CITY OF ALBUQUERQUE

Re: GS 4th LLC
2204 Menaul Blvd NE
Traffic Circulation Layout
Architect's Stamp 08-21-17 (H16-D150)

Based upon the information provided in your submittal received 08-16-17, the above referenced plan cannot be approved for Building Permit until the following comments are addressed:

2 A1 EXISTING SITE AERIAL PHOTO

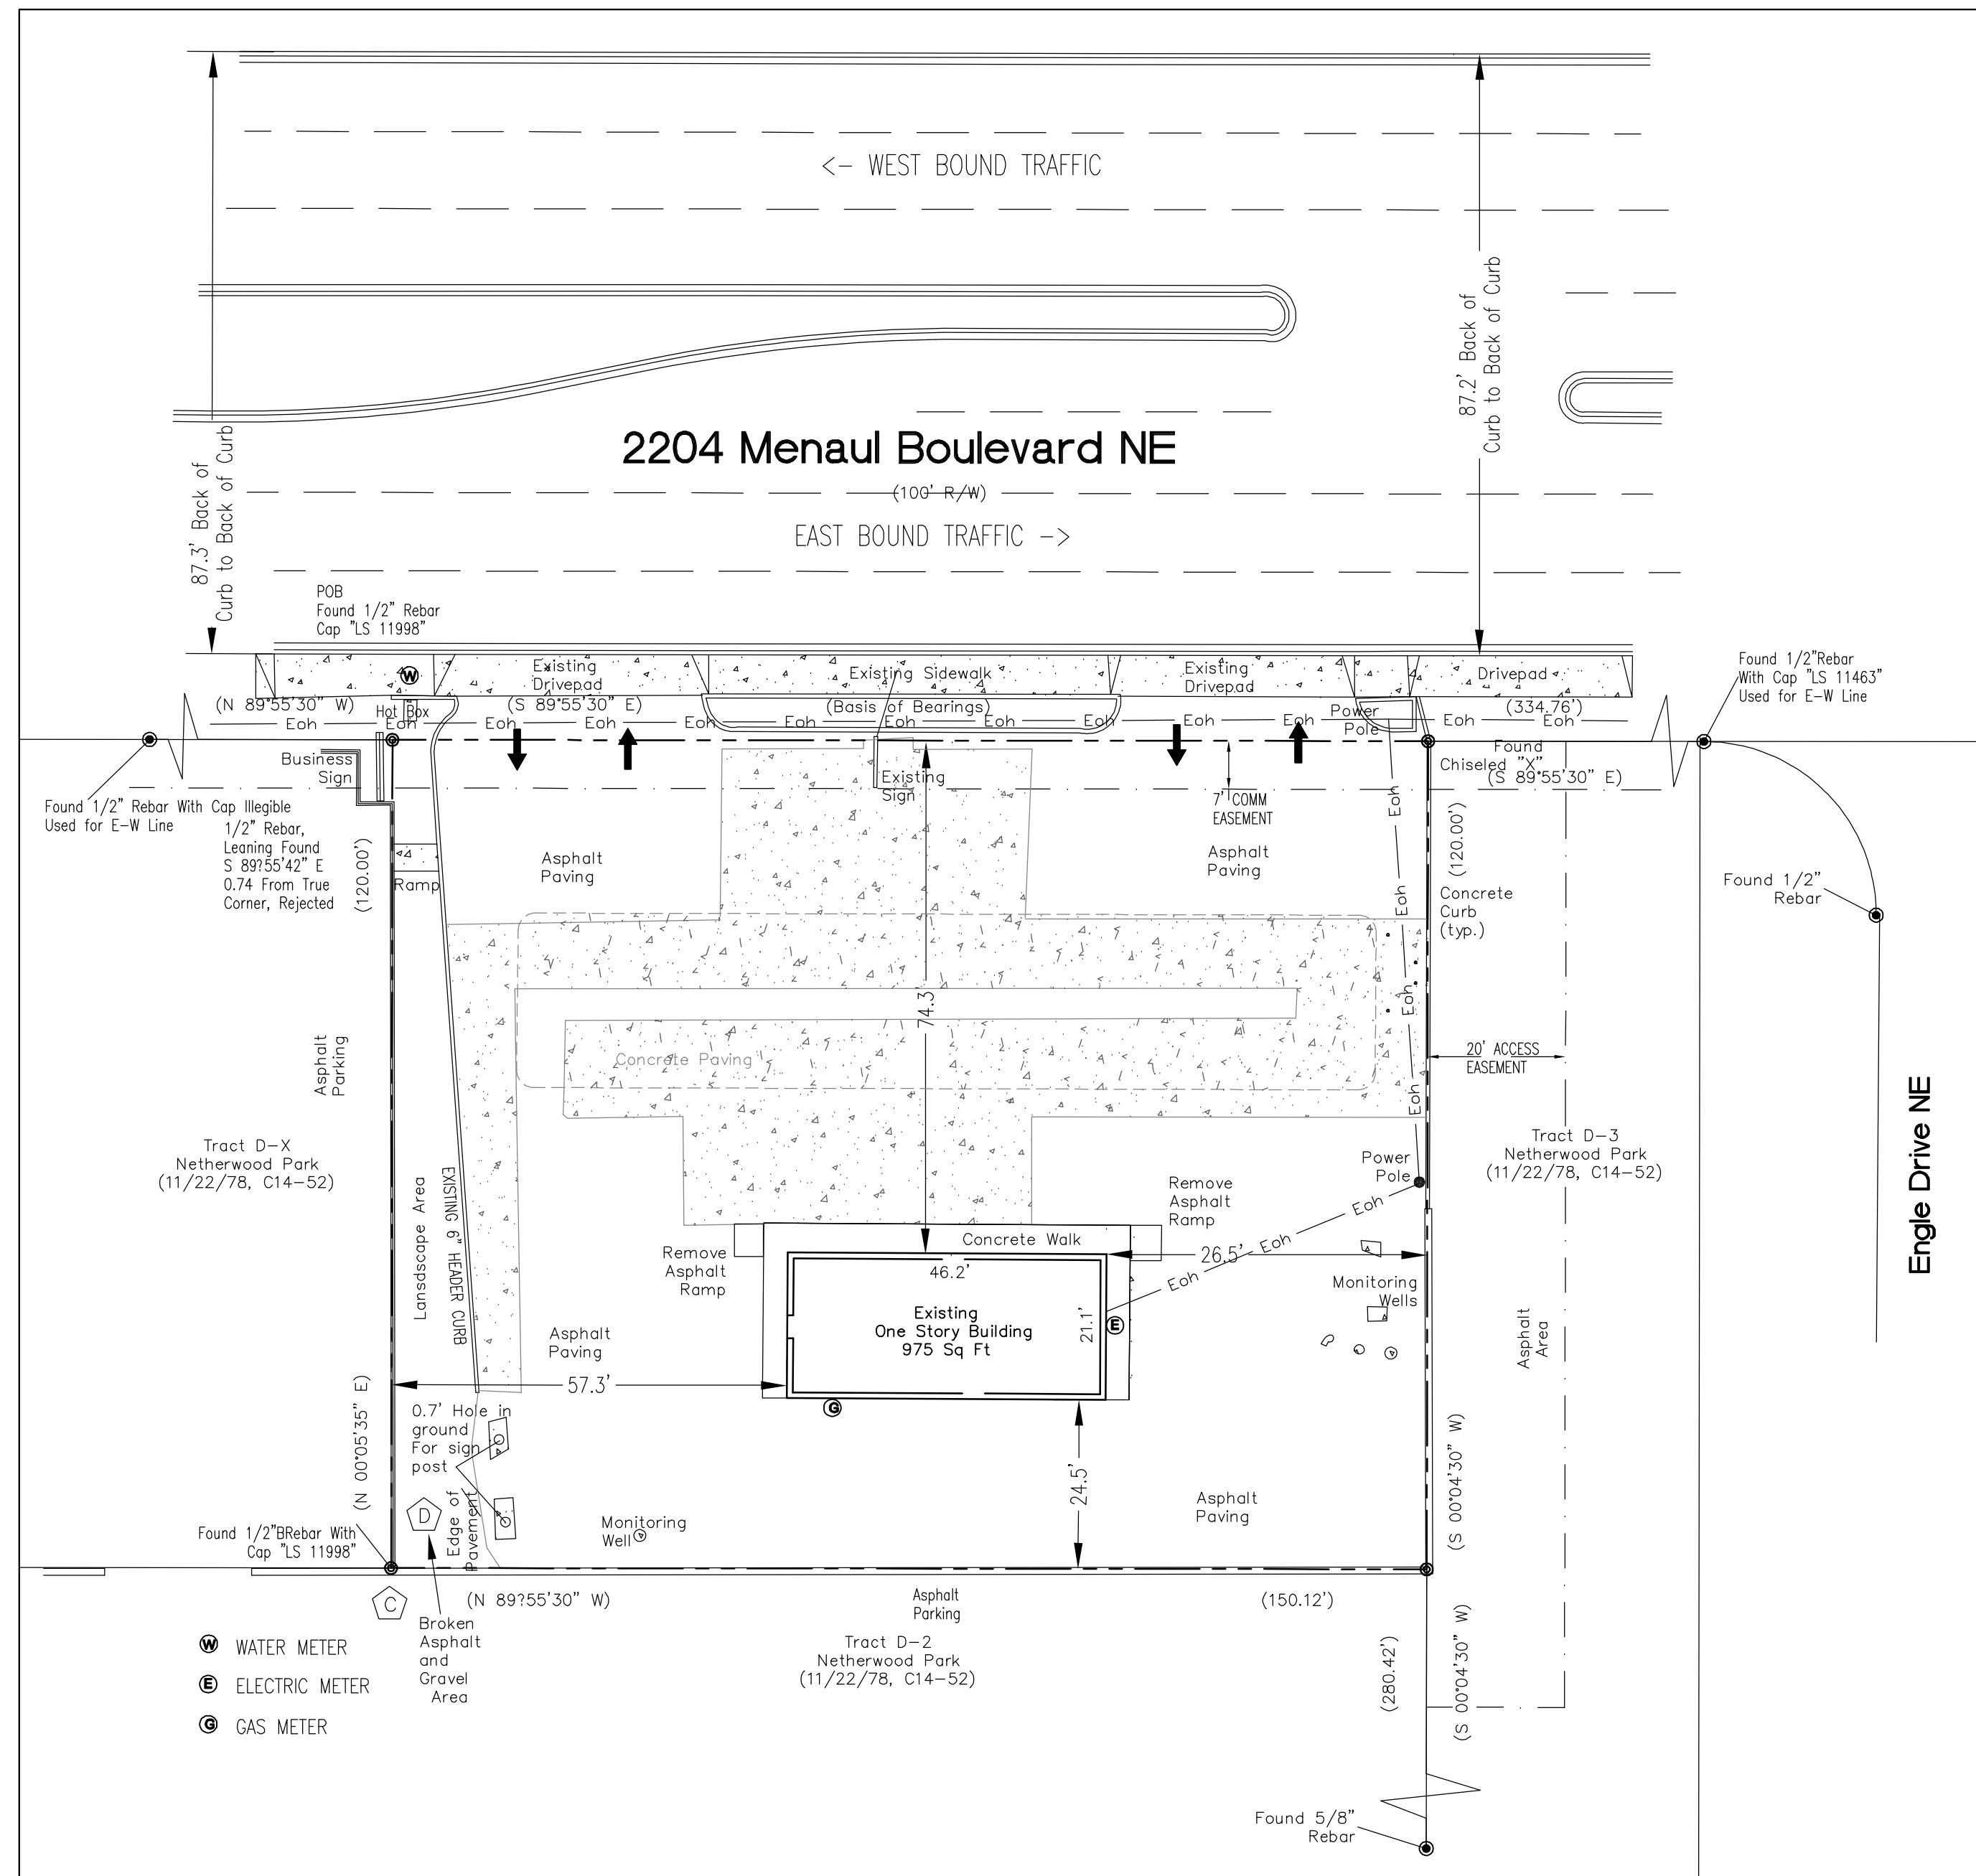
1. Please show a vicinity map showing the location of the development in relation to streets and well known landmarks. The map on the TCL should show the nearest cross street.

1 TRAFFIC CIRCULATION PLAN
A1a SEE ATTACHED BOUNDARY & ALTA/NSPS LAND TITLE SURVEYS FOR ADDITIONAL INFORMATION

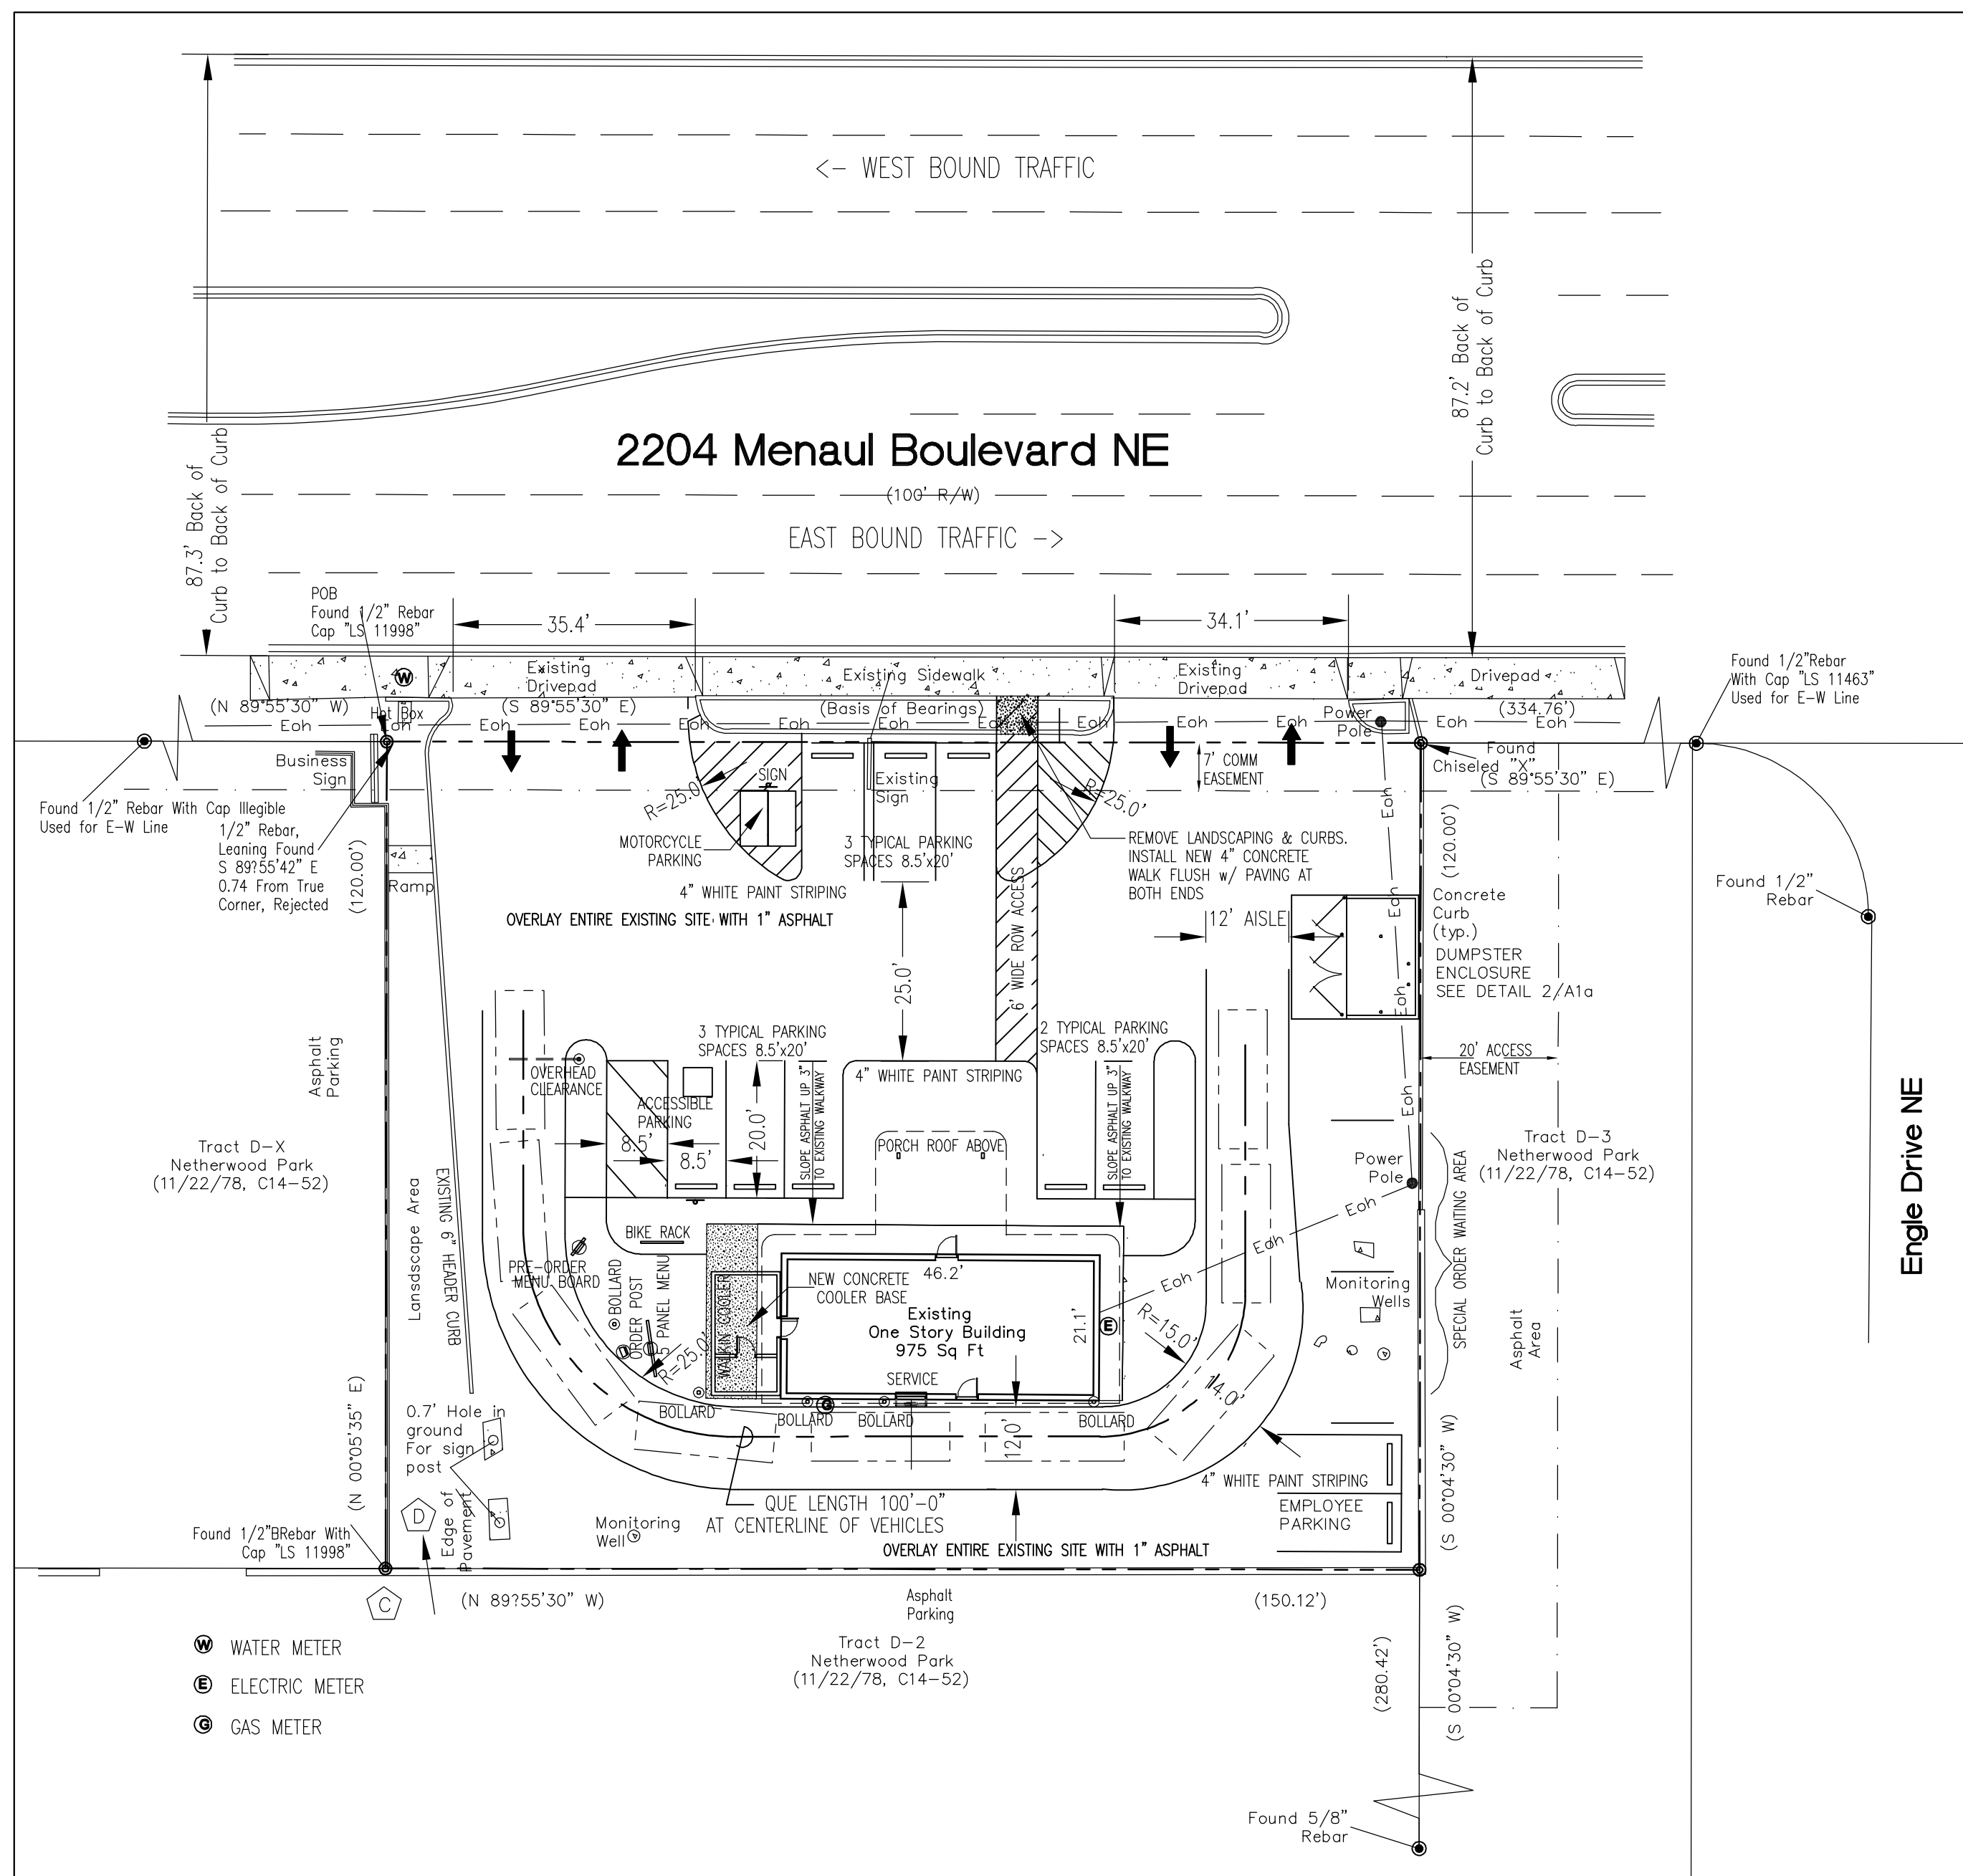
2. List the number of parking spaces required by the zoning code as well as the proposed number of parking spaces including bicycle and motorcycle parking. The parking calculations for the restaurant do not follow the requirements in the zoning code, please revise.

3. Please list the width and length for all existing and proposed parking spaces. Some dimensions are not shown. Parallel parking should follow the DPM requirements. The motor cycle and employee parking spaces are missing dimensions.

4. Show all drive aisle widths and radii. Some dimensions are not shown. Dimension the width from the back and sides of the building to the edge of usable pavement.

5. Per DPM, a 6 ft. wide ADA accessible pedestrian pathway is required from the HC parking stall access aisles to the building entrances. Please clearly show this pathway and provide details. Please show the ADA path from the accessible parking to the entrance with slope limits.

6. Service vehicle and/or refuse vehicle maneuvering must be contained on-site; provide a copy of refuse approval.
7. One-way vehicular paths require pavement directional signage and a posted **"Do Not Enter"** sign at the point of egress. Please show detail and location of posted signs.

8. Add a note stating "All broken or cracked sidewalk must be replaced with sidewalk and curb & gutter." A build note must be provided referring to the appropriate City Standard drawing.
9. We would like to see curbing around the parking at the north front of the site. Especially by the pedestrian connection.
